Strategic Housing Development Large Scale Residential Development at Hartfield Place, Swords Road, Whitehall, Dublin 9

Response to ABP Opinion and DCC comments on Pre
Application Consultations

Eastwise Construction Swords Limited.

March 2022

Figure 2.1 Proposed General Arrangement (Bus Connects) (AECOM Drawing PR379360-ACM-XX-XX-DR-CE-20-0001A)

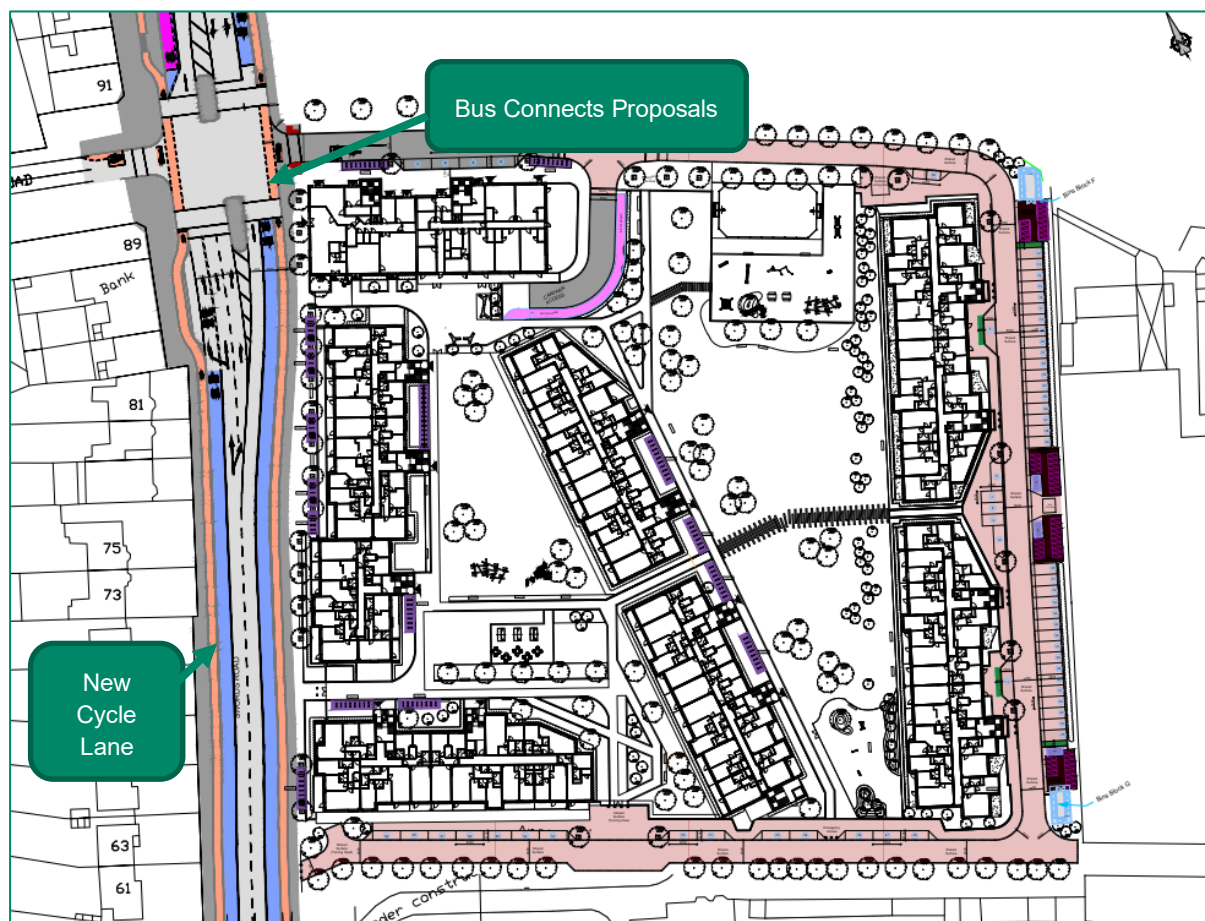
The proposed site access arrangement and western boundary proposals should be agreed with the National Transport Authority (NTA) to ensure that the proposals do not conflict with the Bus Connects proposals. This division can facilitate engagement with the NTA upon request from the applicant prior to the submission of a final application.

The latest layout for taking cognisance of NTA Bus Connect proposals are shown below in Figure 2.1 and detailed in AECOM Drawing number PR379360-ACM-XX-XX-DR-CE 20-0001. This drawing has been passed onto Bus Connects Team via Dublin City Council Transport Planning team by email for comment.

Figure 2.2 Proposed General Arrangement (AECOM Drawing PR379360-ACM-XX-XX-DR-CE-10-0001C)

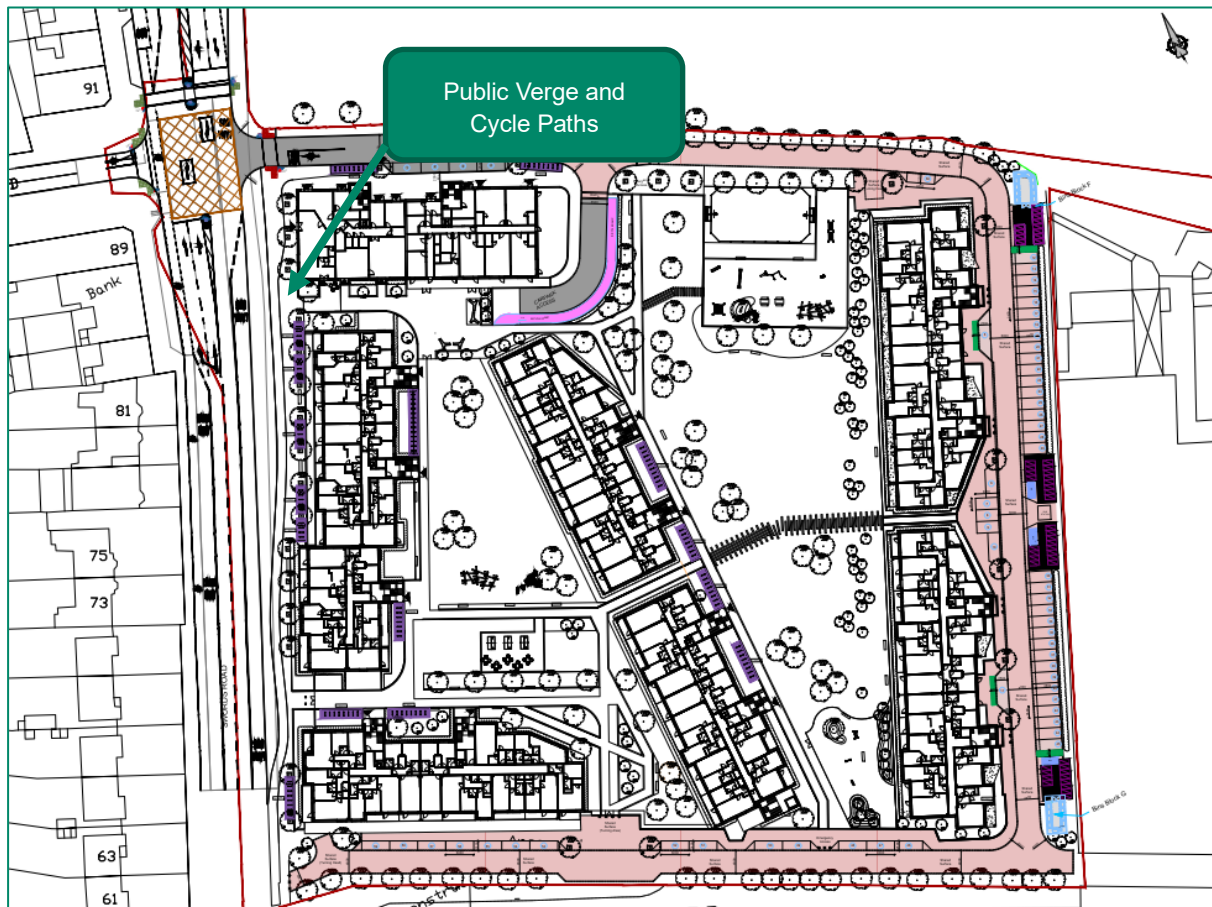
This division requires that a public footpath of 2.0 minimum width is retained under the charge of DCC along Swords Road. The applicant is requested to submit revised drawings on the proposed replacement of the existing public footpath with a cycle path and grass verge along Swords Road showing the proposed new cycle path, grass verge and public footpath along the western boundary of the site on Swords Road.

AECOM Drawing PR379360-ACM-XX-XX-DR-CE- 00-0001 General Arrangement in Figure 2.2 shows the proposed public footpath and grass verge with the new signalised access to the development, along the western boundary of the site on Swords Road. Currently cycling is permitted within the citybound bus lane so an

additional cycle path had not been included in this drawing. A new cycle path public footpath and verge has been included in the option as per drawing for BusConnects (see response to Item 2)

The development proposes a new signalised access off Swords Road opposite Iveragh Road. This converts the existing three armed priority junction to a 4 armed signalised junction. This was previously shown in Figure 2.2 Proposed General Arrangement (AECOM Drawing PR379360-ACM-XX-XX-DR-CE-10-0001C)

Figure 2.3 Basement Layout (Source: C+W O'Brien Architects Drawing No. 092035)

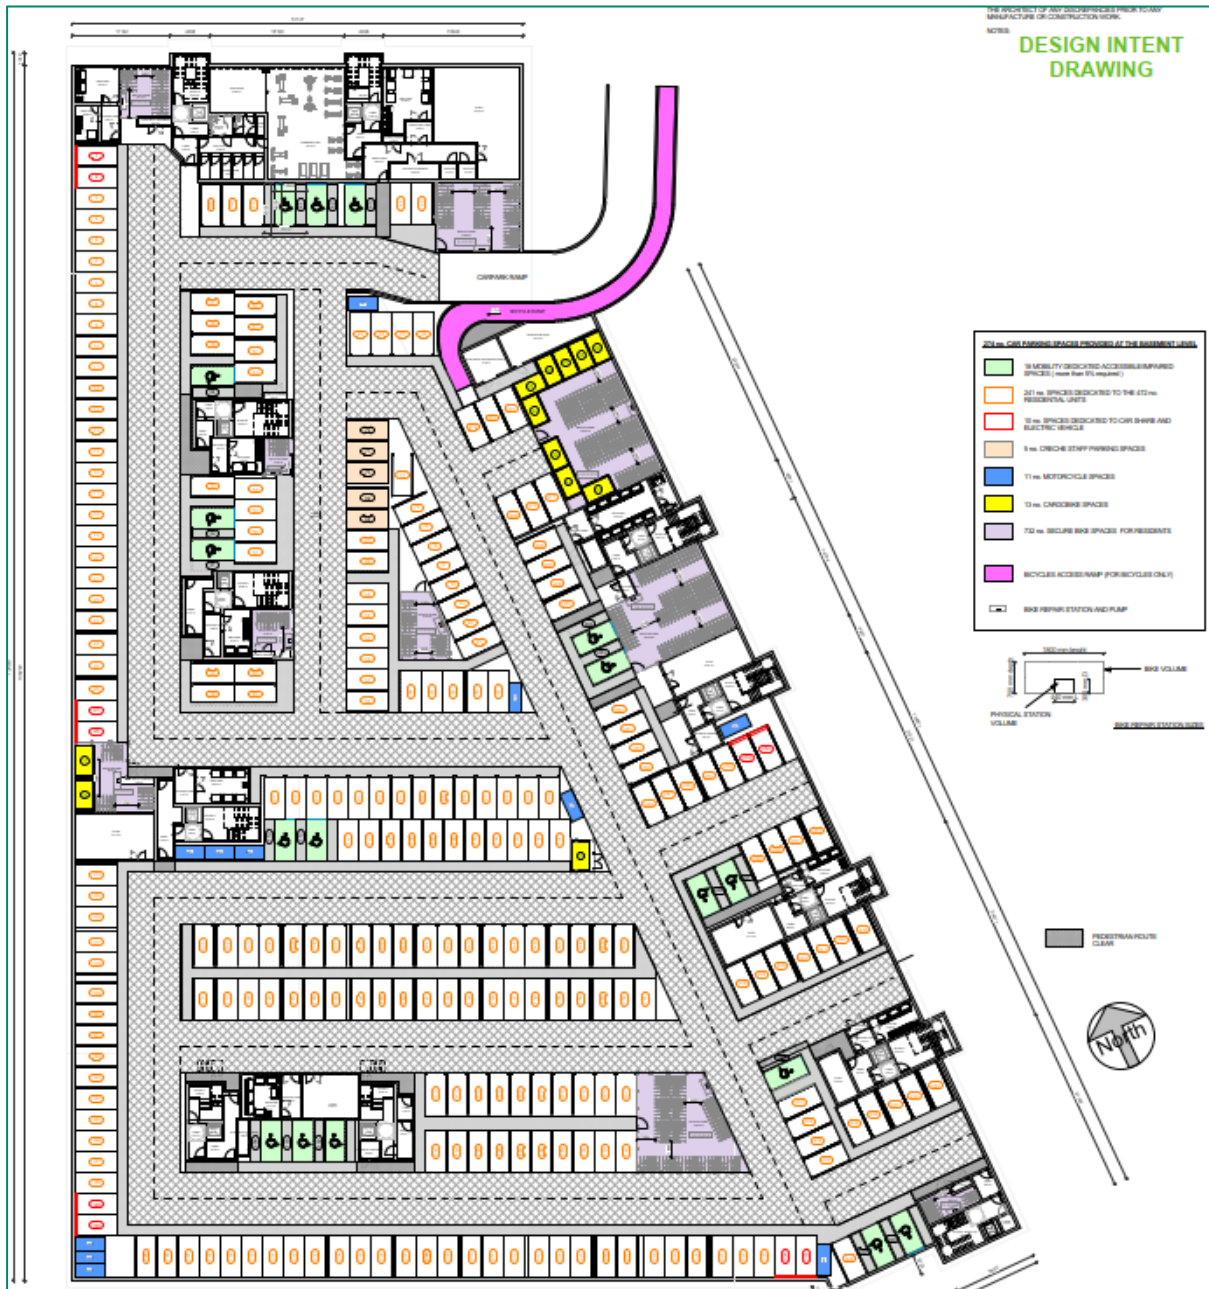
- a) Confirm the total number of parking bays to be allocated to residents;

AECOM Response: 274 no. at basement, 60 no. at surface total. In total 308 no. parking spaces are allocated to residents. see architects basement layout (C+W O'Brien Drawing HARTPL-CWO-BT-B1-DR-A-092001) and AECOM |Drawing PR379360-ACM-XX-XX-DR-CE- 00-0001.

Figure 2.5 Car Share Basement Layout (Source: C+W O'Brien Architects Drawing No. 092035)

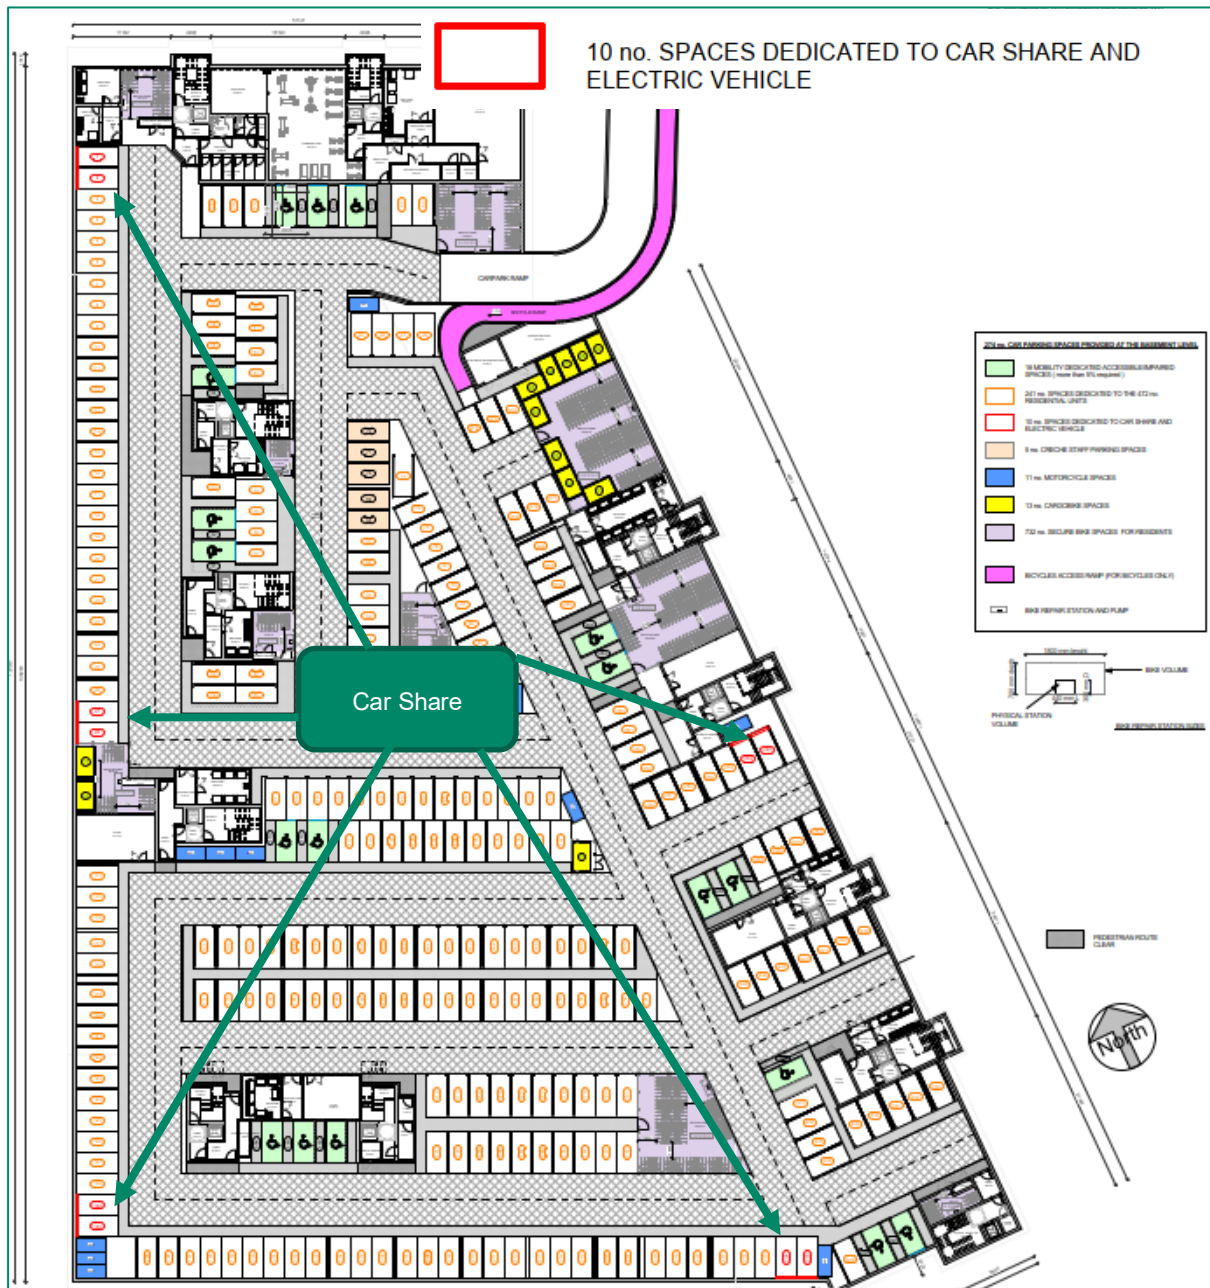
c) Indicate the proposed locations of designated Car Club spaces onsite;

10 no. Car Club spaces are to be provided at basement Level

These are illustrated on C+W O'Brien Drawing HARTPL-CWO-BT-B1-DR-A-092001)

Figure 2.6 Accessible Parking Basement Layout (Source: C+W O'Brien Architects Drawing No. 092035)

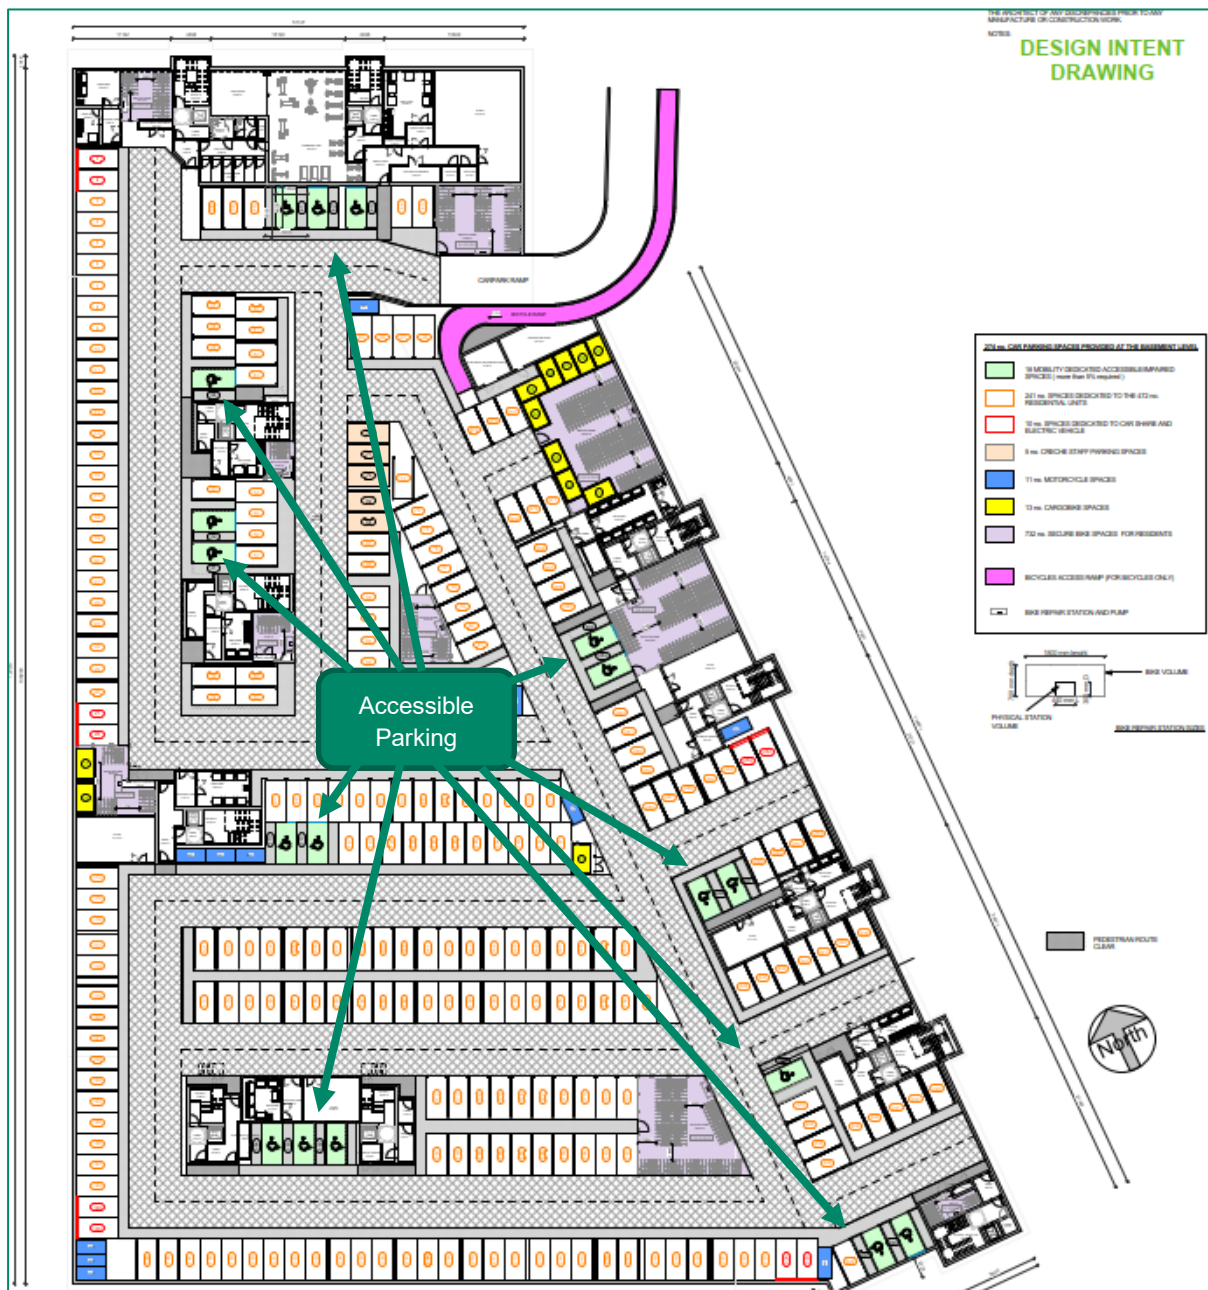
- d) Demonstrate that all accessible parking spaces are located within close proximity of main entrances to the respective Blocks and crèche.

This can be seen on the architects basement plan (C+W O'Brien Drawing 092035) All the accessible parking spaces are located within close proximity of main entrances to the respective Blocks and crèche.

Figure 2.7 Bicycle Store Parking Basement Layout (Source: C+W O'Brien Architects Drawing No. 092035)

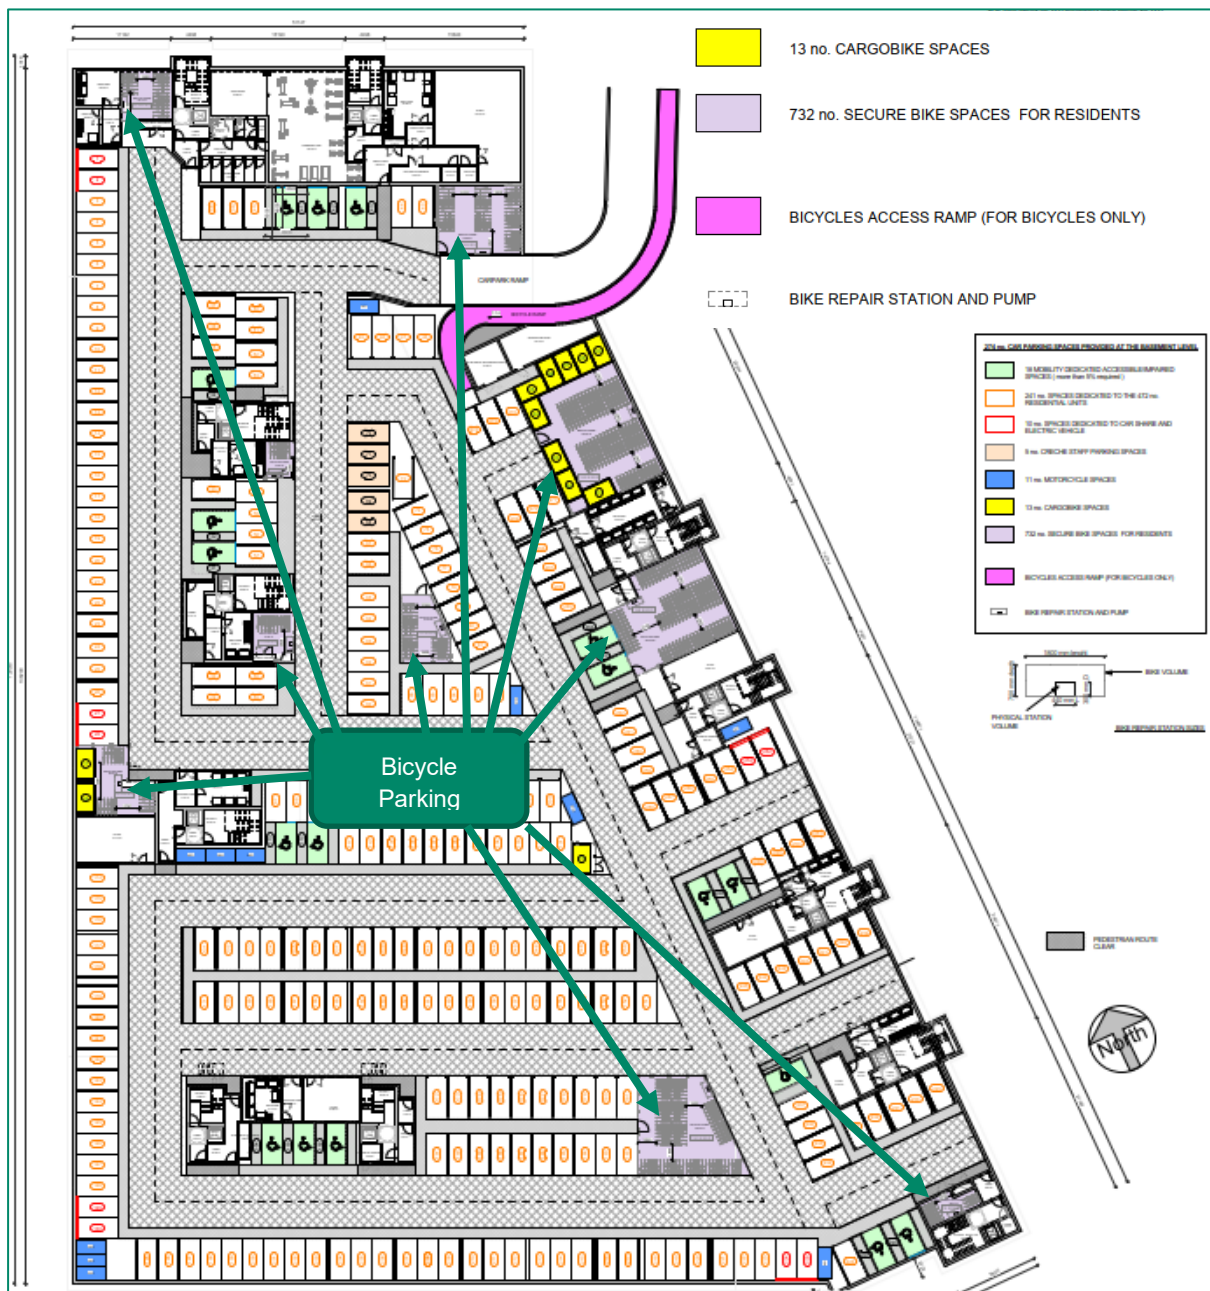
a) The resident bicycle parking ratio of 1:1.1 is determined low having regard to the overall occupancy capacity of the scheme. Increase resident parking onsite.

- c) *Provide details of the number of bicycles parking spaces per compound, type of bicycle parking stands proposed and demonstrate functionality of spaces ensuring ease of access/egress including sufficient space (min. 1.8 metres to the front for access if two-tierstands).*

The bicycle parking provision has been increased. For 472 apartments, there are now 732 secure spaces in basement. In addition, there are 14 cargo bike parking spaces. There are 236 visitor spaces provided at grade throughout the site.

The cycle parking now exceeds the Design Standards for New Apartment Guidelines provisions, for 723 total bedspaces, with visitor matching these guidelines with 1No. space per two apartments

These details are included on the architects basement plan (C+W O'Brien Drawing 092035) and below in Figure 2.7

There are 732 no. proposed secure bicycle parking spaces for residents . the location of these bicycle stroes are illustrated above in Figure 2.7. and drawing no. 092035

Figure 2.8 Cargo Bike Store Parking Basement Layout (Source: C+W O'Brien Architects Drawing No. 092035)

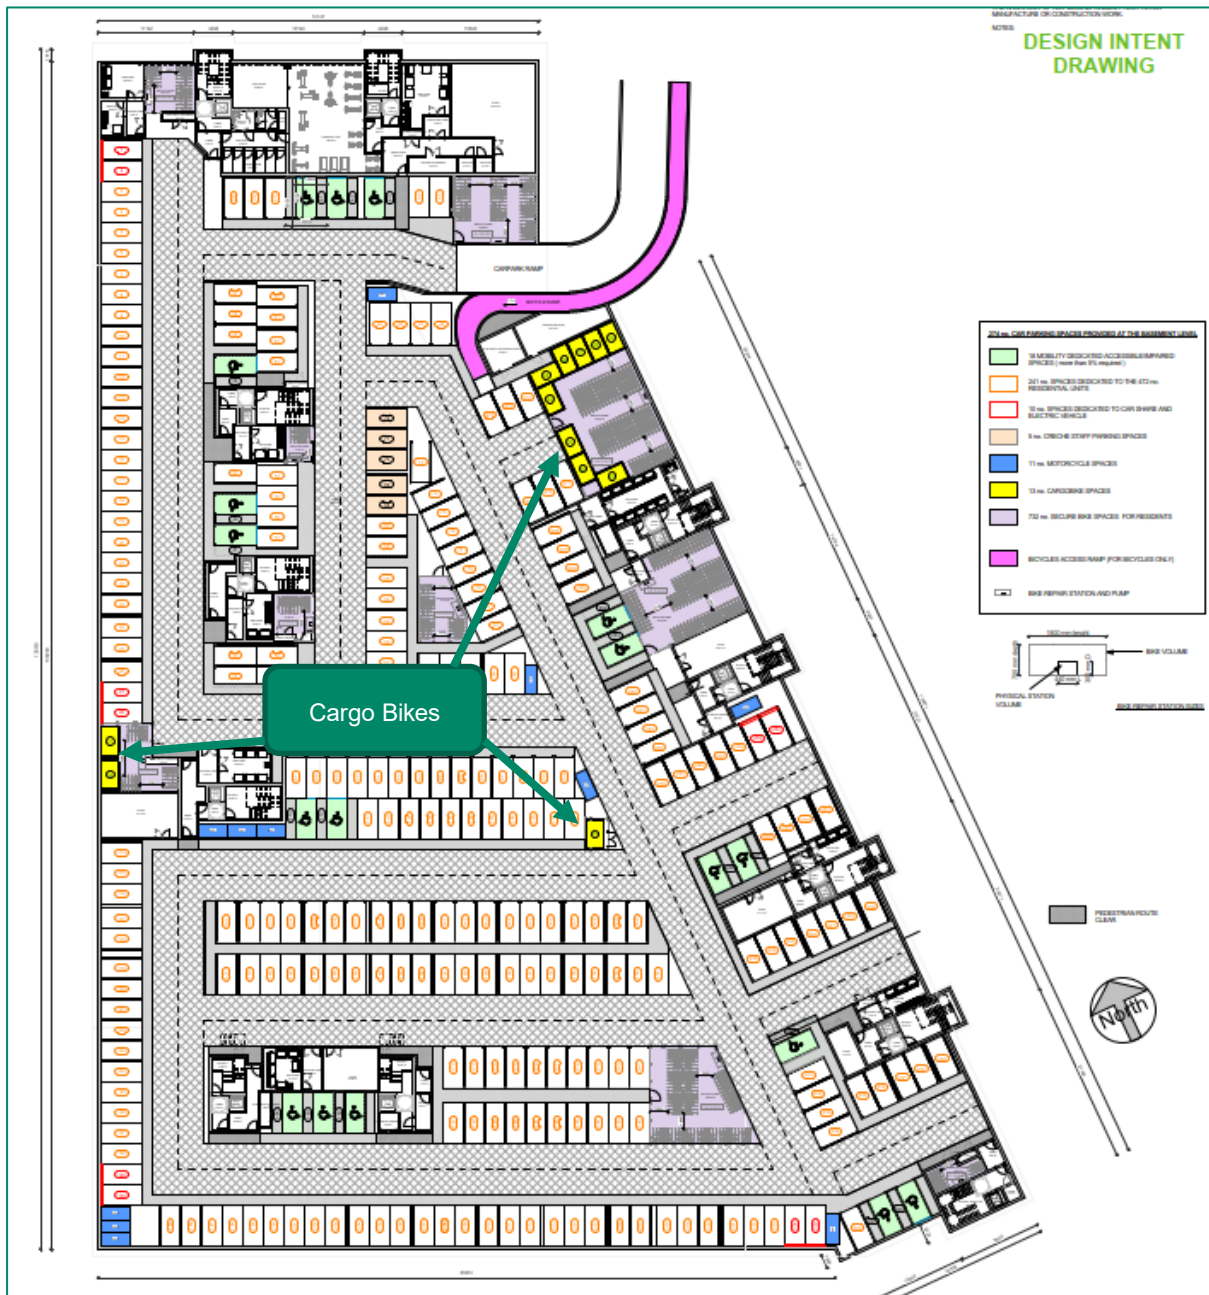
- d) *Provide parking for cargo bicycles.*

Parking for cargo bikes (14 No.) are included on the architects basement plan (C+W O'Brien Drawing no. 092035) and below in Figure 2.8
